**Amendments to the Drawings:**

### REMARKS / ARGUMENTS

Appl. No. 10/712,153  
Amdt. dated 03/28/2006  
Reply to Office action of 09/28/2005

FIG. 1A

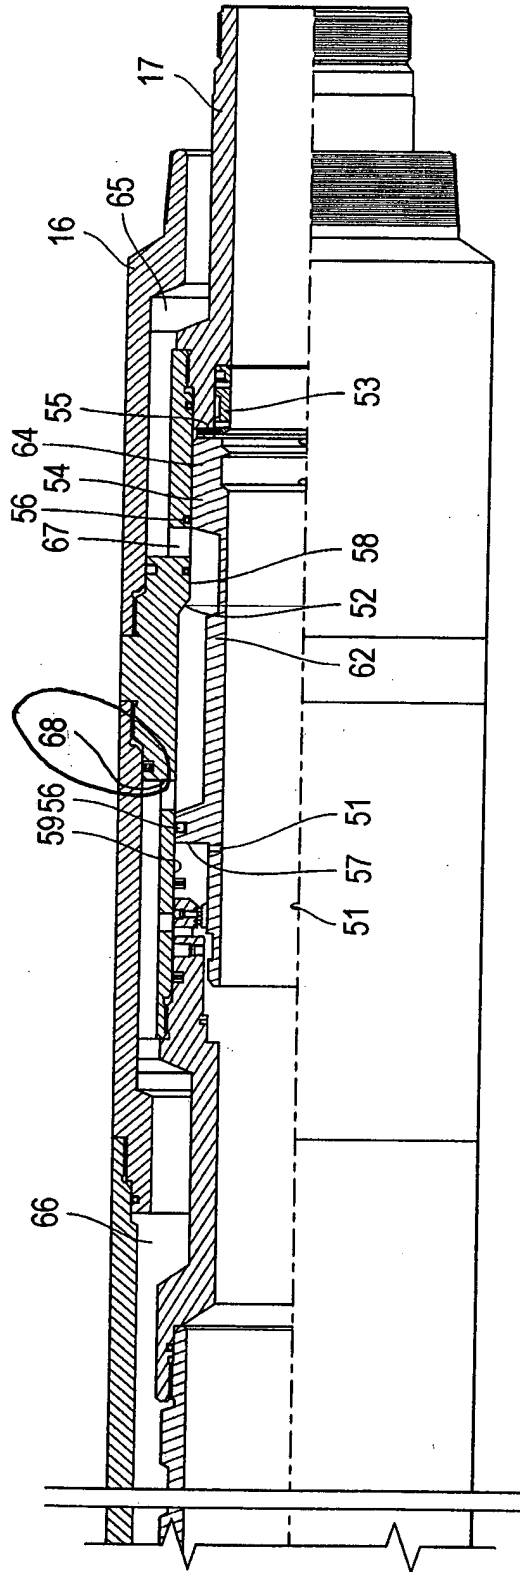
1. On sheet 1/46 in Figure 1A, reference number 68 has been added. Support may be found in paragraph [0057].
2. On sheet 7/46 in Figure 3A, reference numbers 311 and 322 have been added. Support may be found in paragraphs [0062] and [0063].

***3. The drawings are objected to as failing to comply with 37 CFR 1.84(p)(5) because they do not include the following reference character(s) mentioned in the description: 68, 311, 322, and 710.***

Reference number 68 has been added to Figure 1A, and reference numbers 311 and 322 have been added to Figure 3A. No new matter has been added. Applicant was unable to find reference number 710 in the subject specification.

18/46

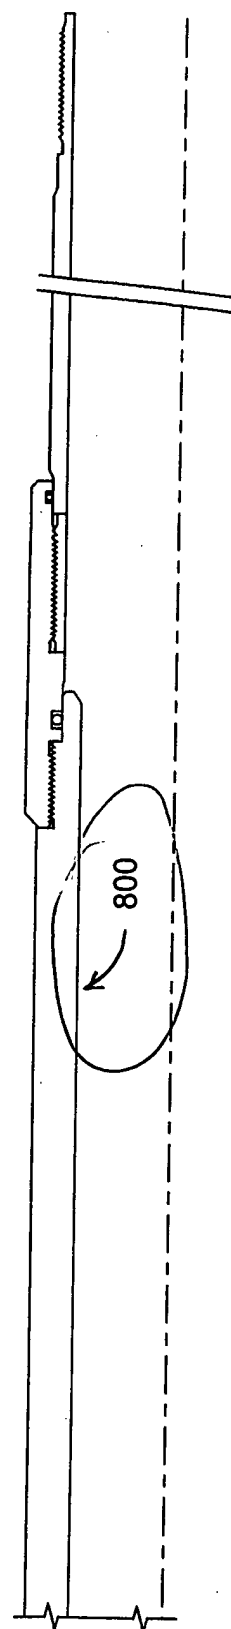
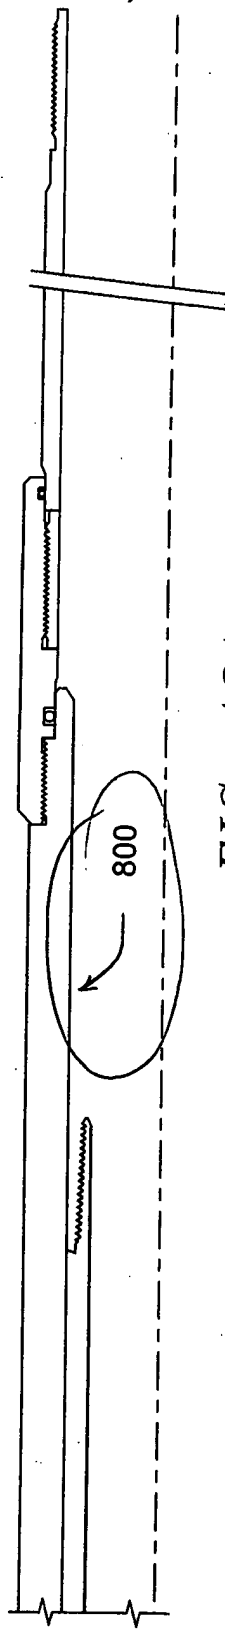
3. On sheet 12/46 in Figure 6C, reference number 46 has been deleted.
4. On sheet 18/46 in Figures 12A, 13A and 14A, reference number 800 has been added. Support may be found in paragraphs [0086] through [0091].

Reference 46 has been deleted from Figure 6C. Figures 12A through 12E, 13A through 13E, 14A through 14E, 15A through 15E and 16A through 16E have been amended by adding one or more reference numerals to place the figure in the context of the existing specification. No new matter has been added.

19/46

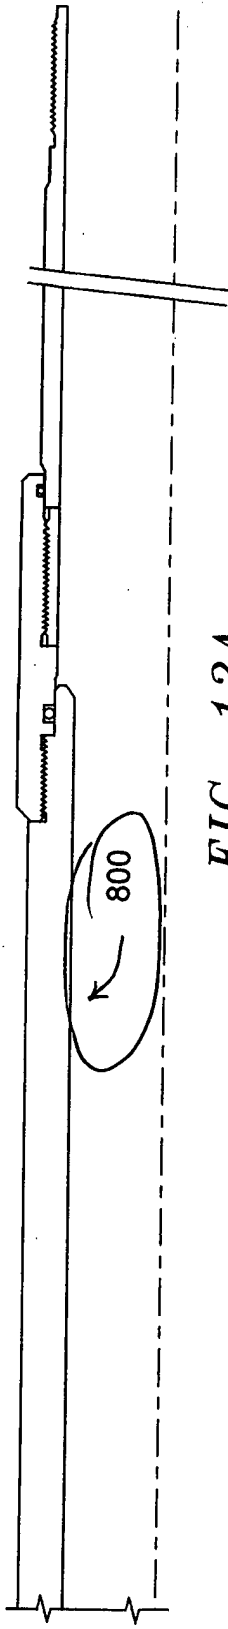
5. On sheet 19/46 in Figures 15A and 16A, reference number 800 has been added. Support may be found in paragraphs [0086] through [0091].
6. On sheet 20/46 in Figures 12B, 13B and 14B, reference number 800 has been added. Support may be found in paragraphs [0086] through [0091].

FIG. 12B

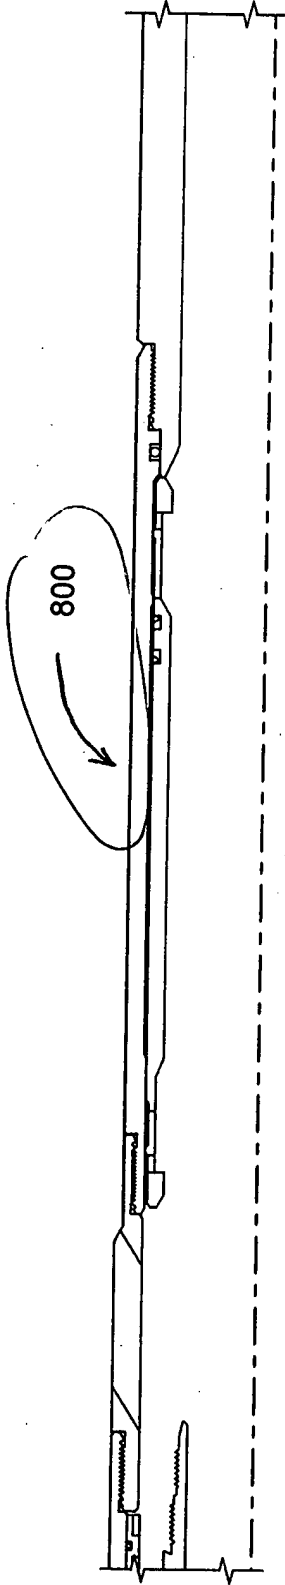
***2. The drawings are objected to because reference character "46" in Figure 6(c) should be deleted and because Figures 12A-16A, 12B, 14B-16B, 15C, 16C, 12D, 14D-16D, and 13E do not contain reference numbers which the examiner considers essential to the understanding of the claimed invention. Applicant is reminded that any reference numbers added to the above figures should be within or added to the specification.***

FIG. 12C

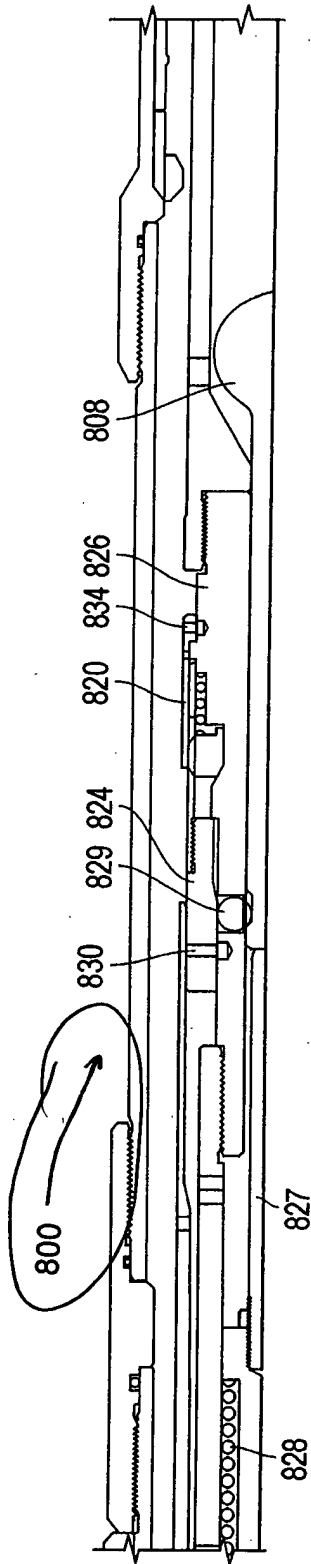
7. On sheet 21/46 in Figures 15B, 16B, reference number 800 has been added. Support may be found in paragraphs [0086] through [0091].
8. On sheet 22/46 in Figures 12B, 13B and 14B, reference number 800 has been added. Support may be found in paragraphs [0086] through [0091].

FIG. 15C

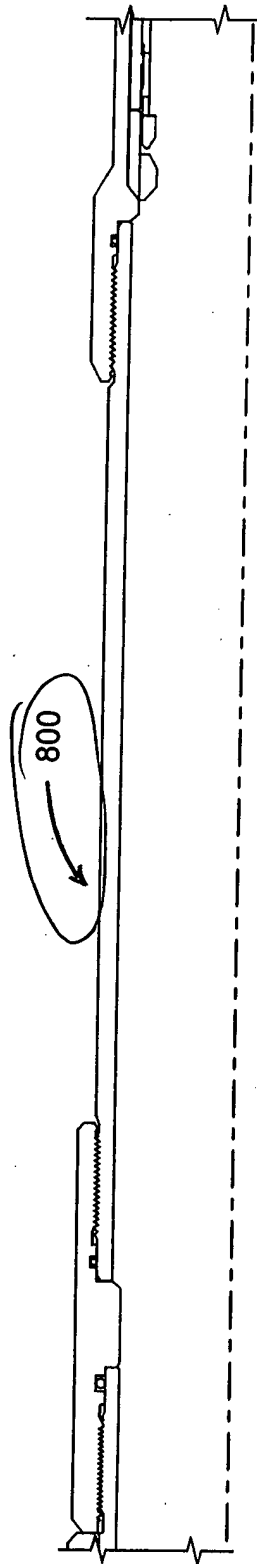
9. On sheet 23/46 in Figures 15C, 16C, reference number 800 has been added. Support may be found in paragraphs [0086] through [0091].
10. On sheet 24/46 in Figures 12D, 13D and 14D, reference number 800 has been added. Support may be found in paragraphs [0086] through [0091].

FIG. 15D

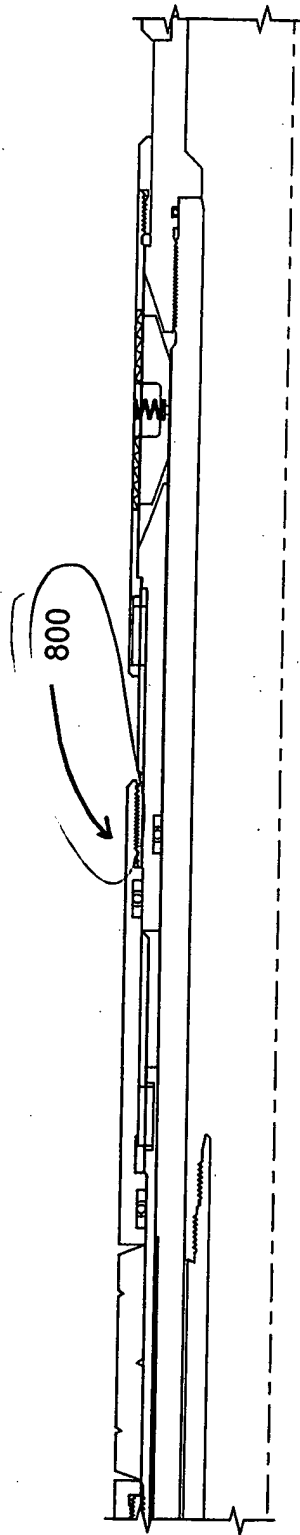
11. On sheet 25/46 in Figures 15D, 16D, reference number 800 has been added. Support may be found in paragraphs [0086] through [0091].
12. On sheet 26/46 in Figures 12E, 13E and 14E, reference numbers 800 and 835 have been added. Support may be found in paragraphs [0086] through [0091].
13. On sheet 27/46 in Figures 15E, 16E, reference number 800 has been added. Support may be found in paragraphs [0086] through [0091].
